**TO:** Tasha Bolivar, Galloway and Company  
**FROM:** Amber Wood Hicken, Planner I  
**DATE:** 5/25/23  
**SUBJECT:** Parker and Pine F1 L1 – In-n-Out Burger, Site Plan  
Review Comments 02

# CIRCLE K SITE DEVELOPMENT PLAN

**SITE DEVELOPMENT PLAN**

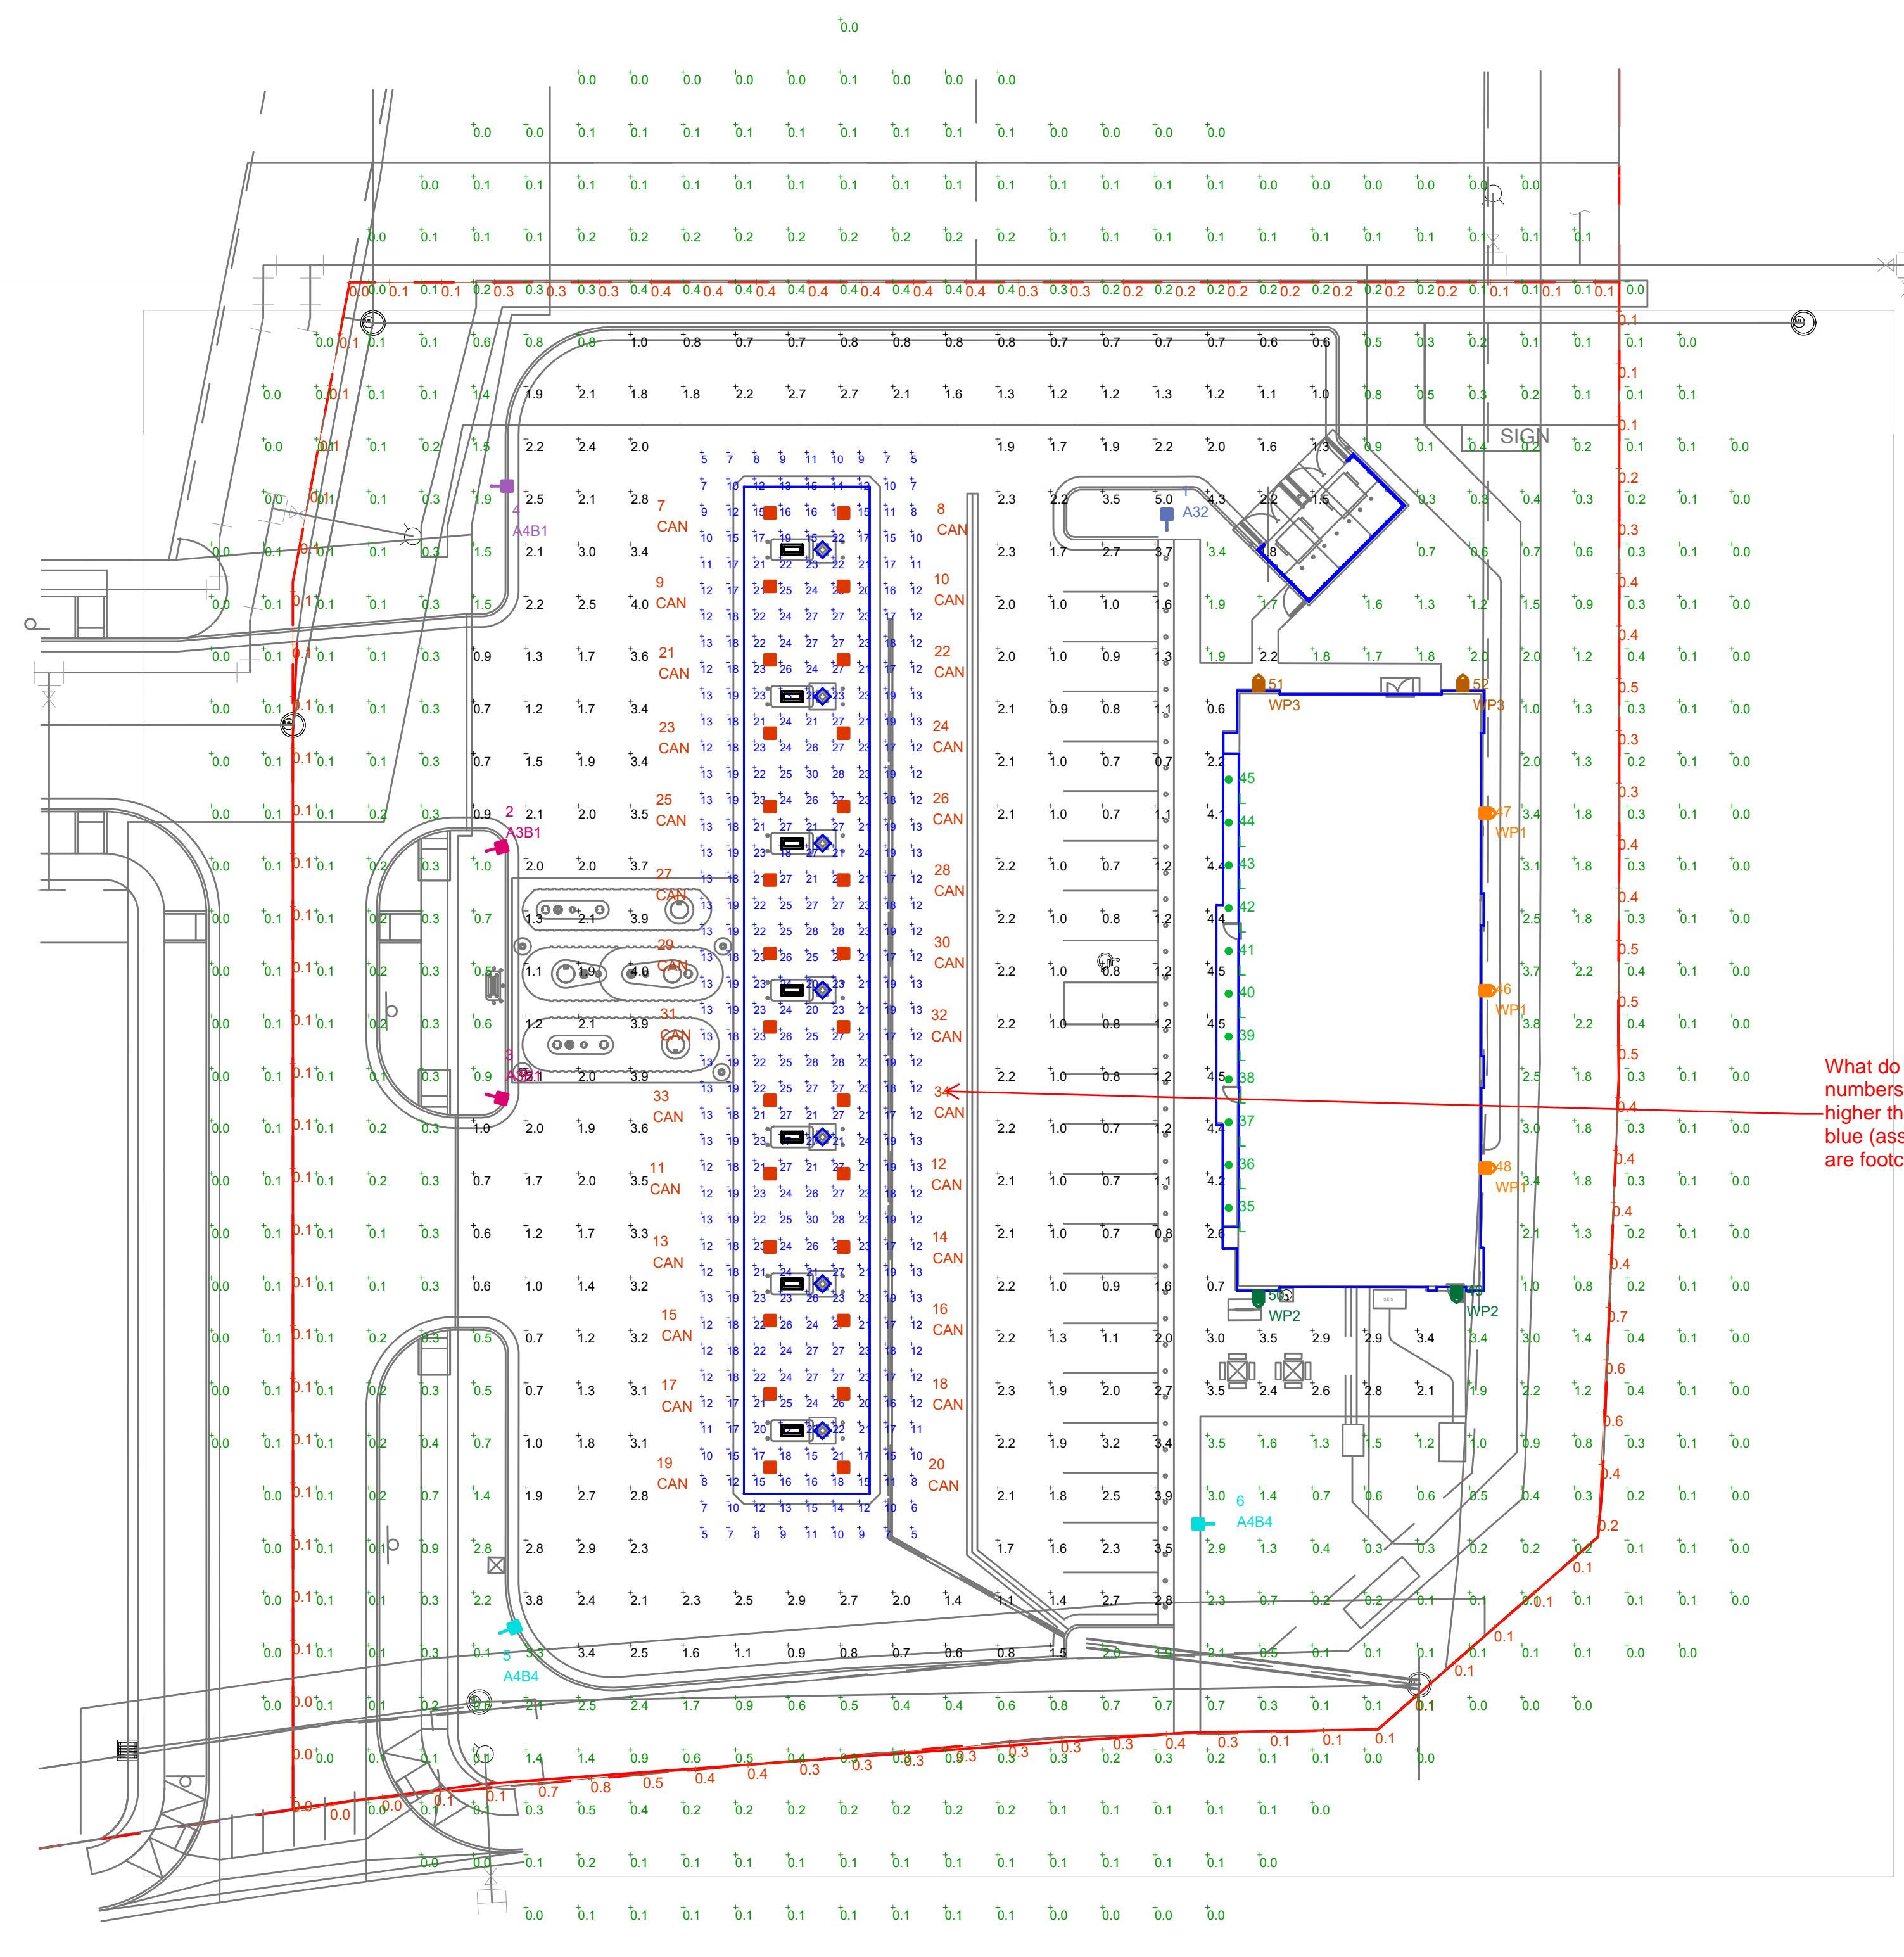
What do the orange numbers mean? Much higher than what's in blue (assuming both are footcandles)

Please include luminaire colors

**4** TYP. FRONT CONCRETE SIDEWALK + BOLLARD  
1/8"=1'-0"

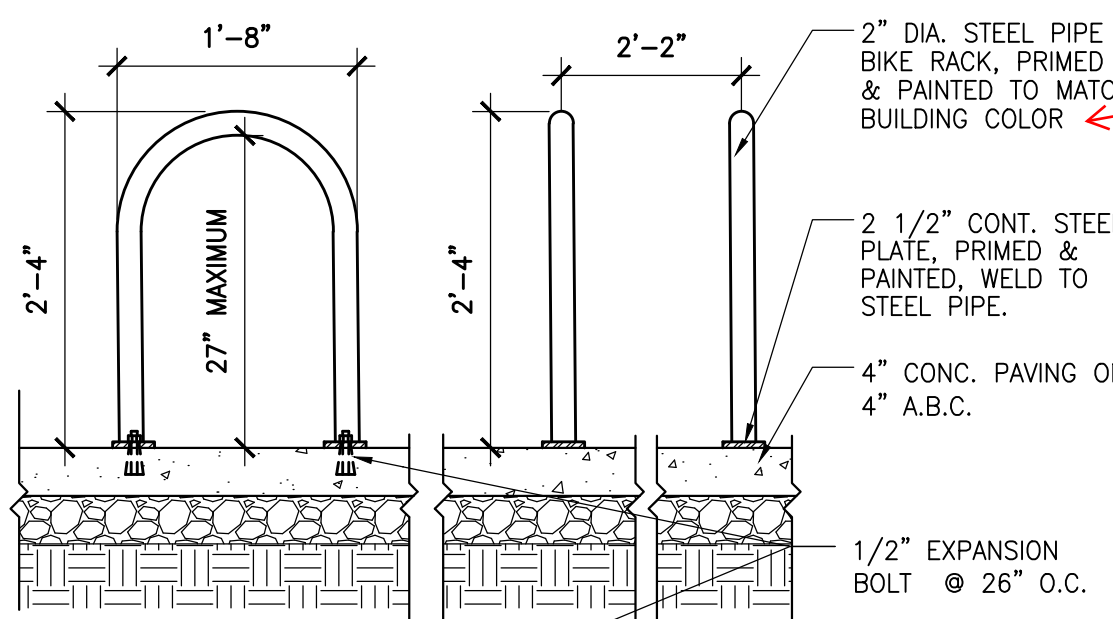
Please provide paint color
